ADDENDUM NO. 04 (MEPT)

Date of Issuance: April, 23, 2026

Project: **Replacement Elementary on Mustang Rd.**
Alvin Independent School District

Texas Arcadis Inc.
Project No.: 202502 - 30268973

P4.01
ENLARGED
PLUMBING PLANS

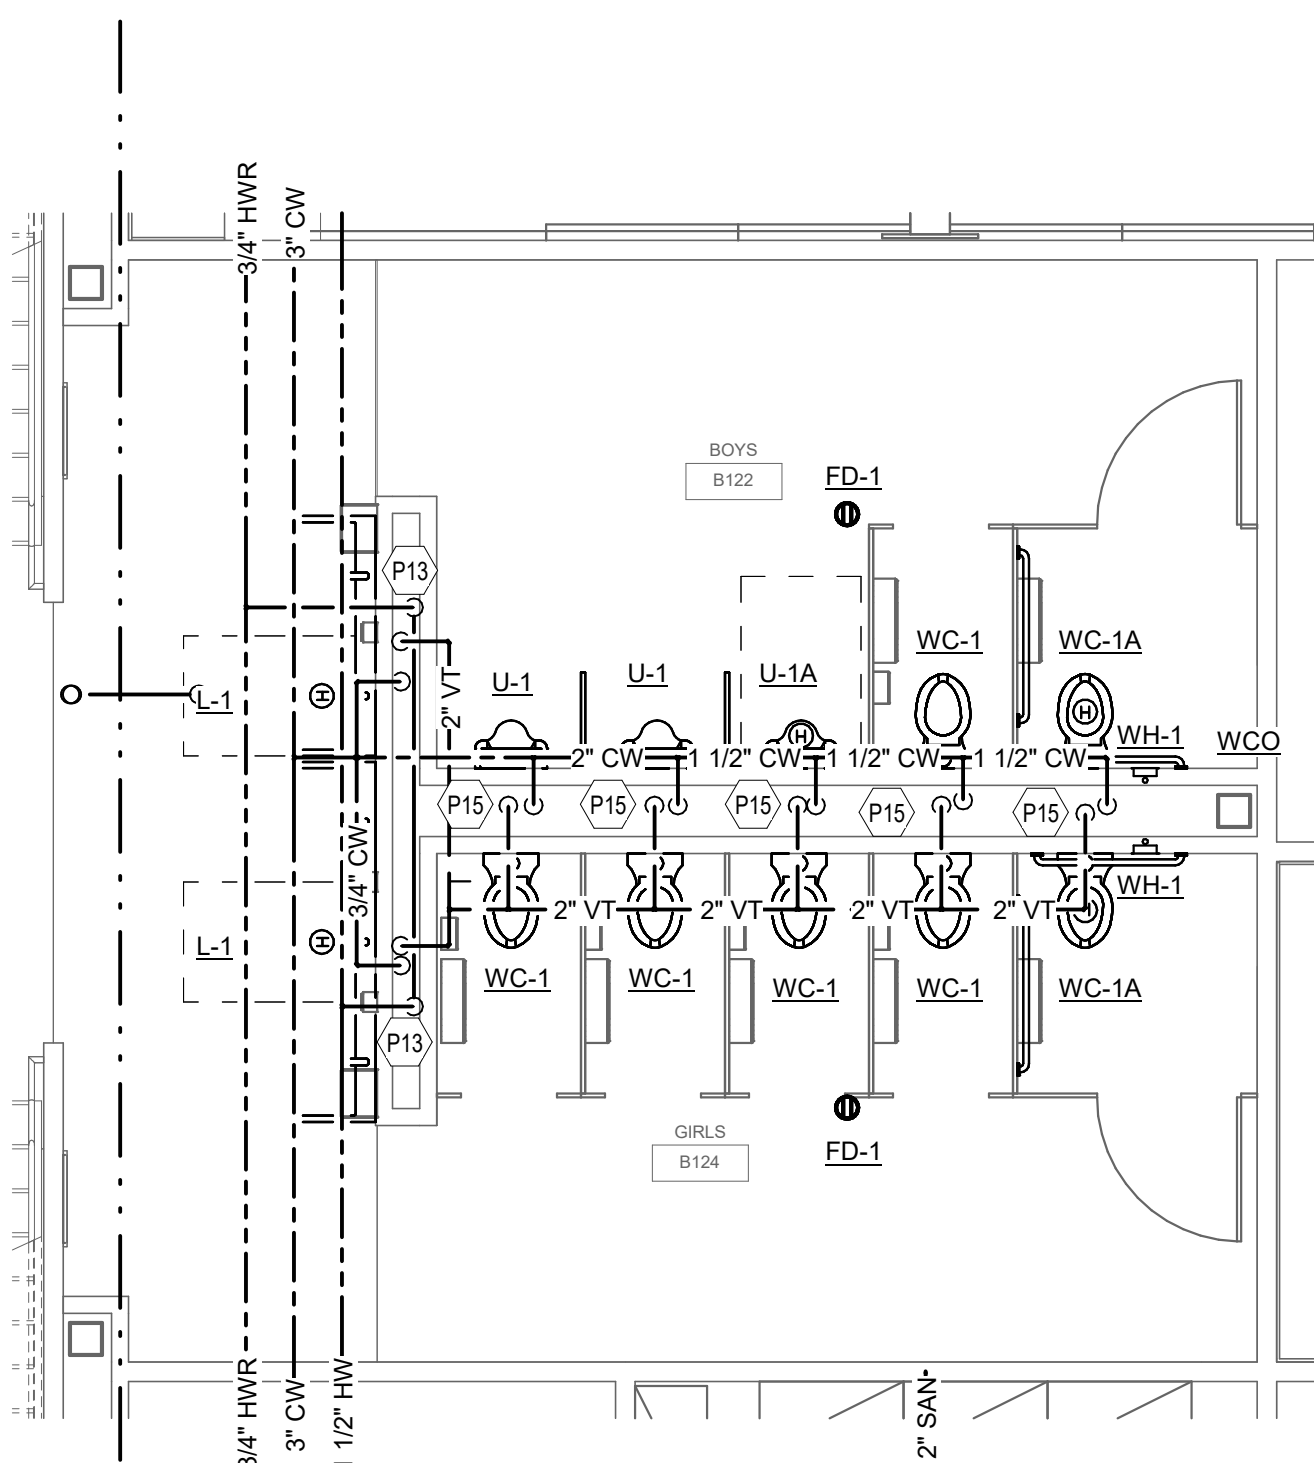
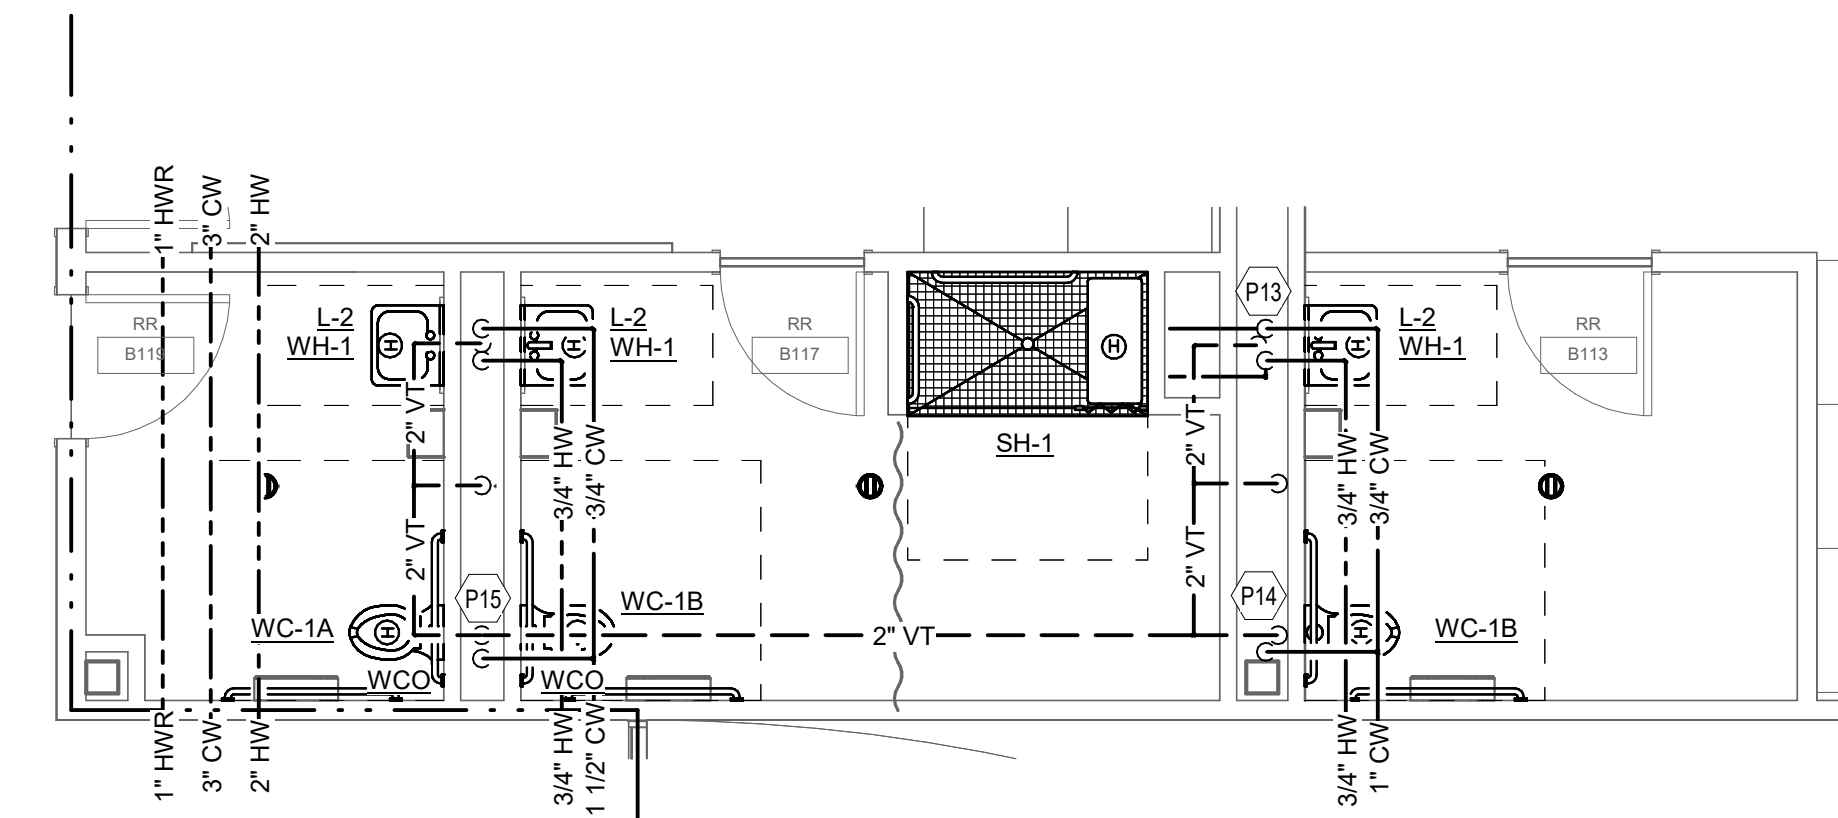
32. Sheet P2.23 – LEVEL 2 PLUMBING - AREA C2
 - e. Added routing notes.
33. Sheet P2.24 – LEVEL 2 PLUMBING - AREA D2
 - f. Added routing notes.
34. Sheet P4.01 – ENLARGED PLUMBING PLANS

- g. Revised tags and plumbing line routing.
35. Sheet P4.02 – ENLARGED PLUMBING PLANS
 - h. Revised tags and plumbing line routing.
36. Sheet P5.02 – LEVEL 1 - KITCHEN ENLARGED PLAN

1 Level 1 Kitchen Plumbing Plan
1/4" = 1'-0"

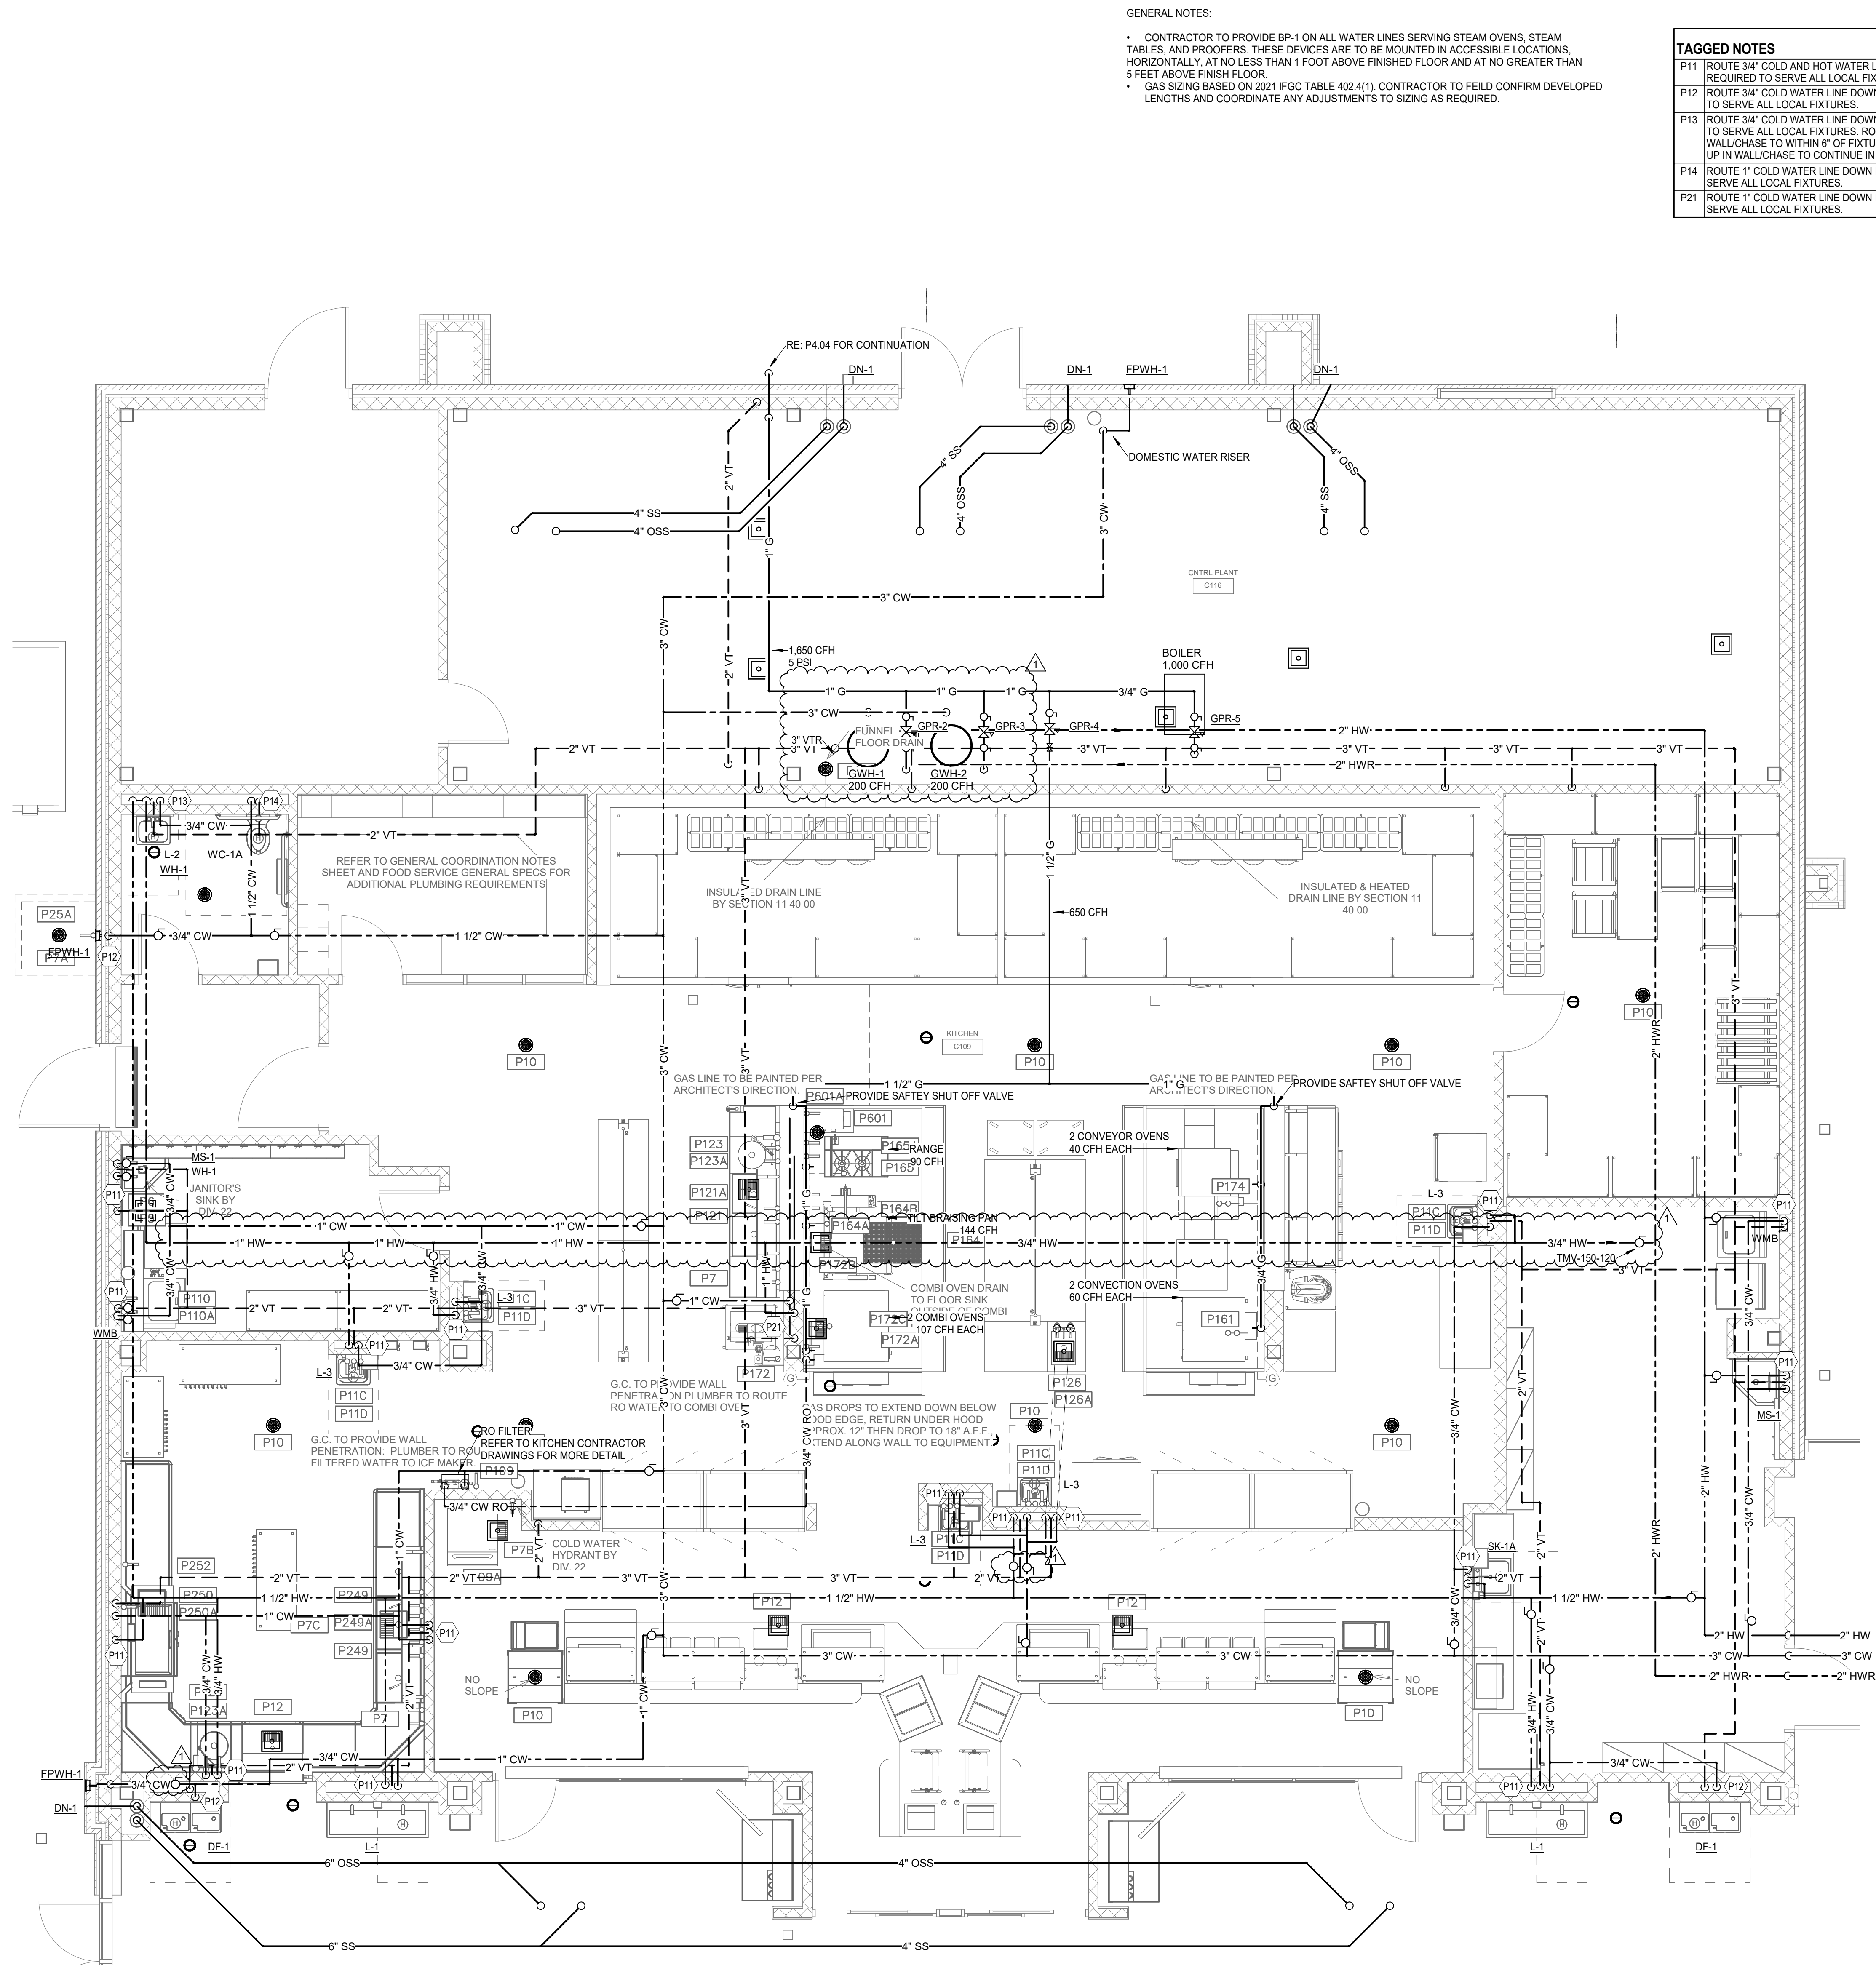
- i. Revised cold and hot water routing.
37. Sheet P6.01 – PLUMBING SCHEDULES
 - j. Revised schedule.
38. Sheet P6.04 – PLUMBING DETAILS
 - k. Detail revised.

P6.04

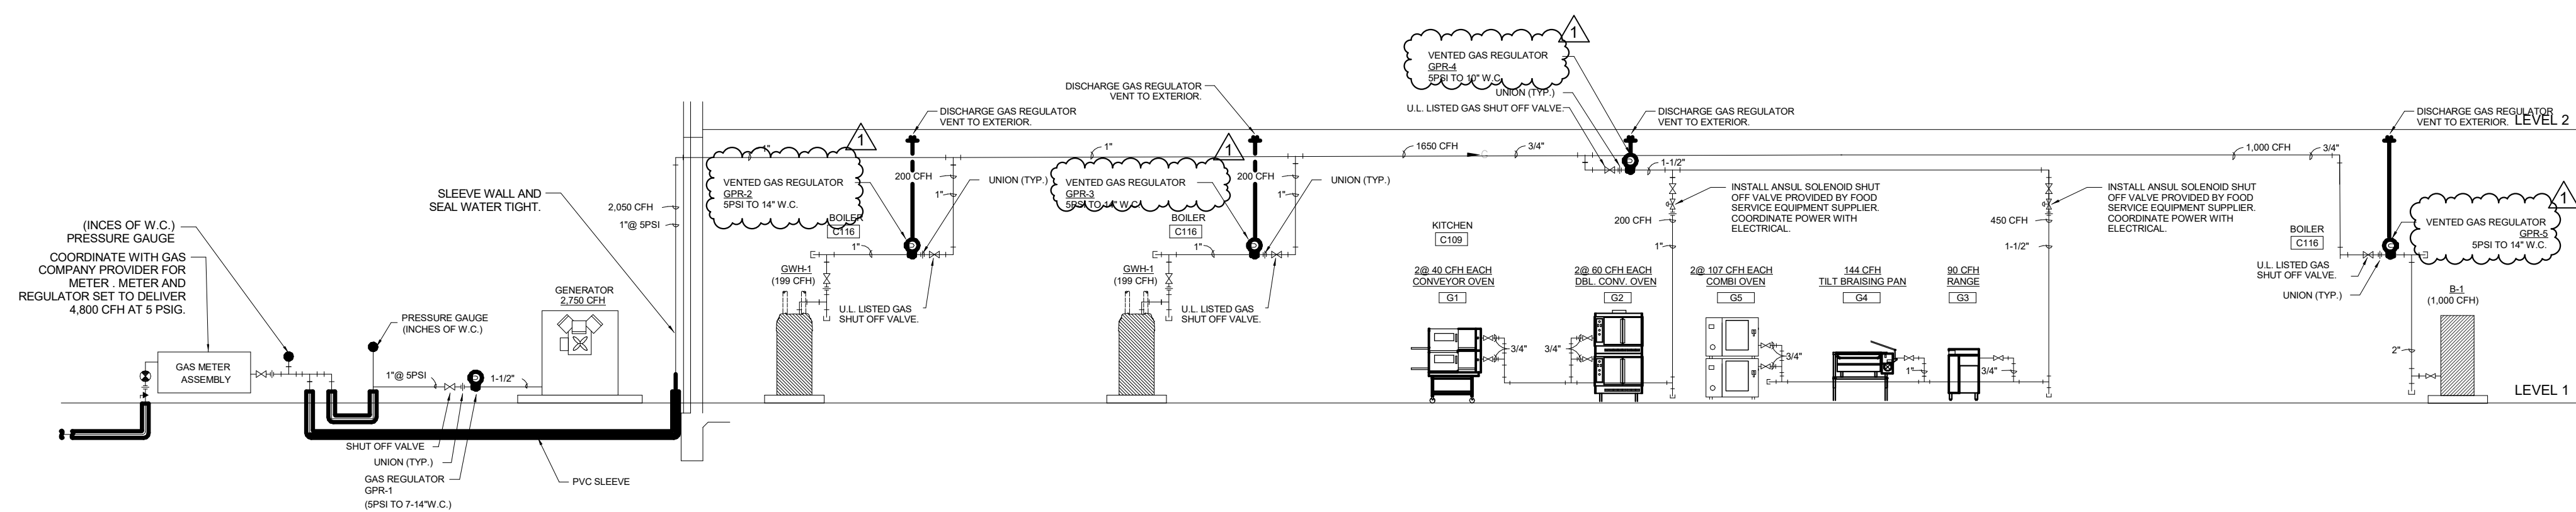
14. Plumbing RFI 6: Are bentonite or clay plugs necessary?
 - a. **CMTA Response:** Yes, refer to reissued sheet P6.04, view 04, for detail.
15. Plumbing RFI 7: Is video inspection or rodding of the underground plumbing systems required to be conducted by a third party?
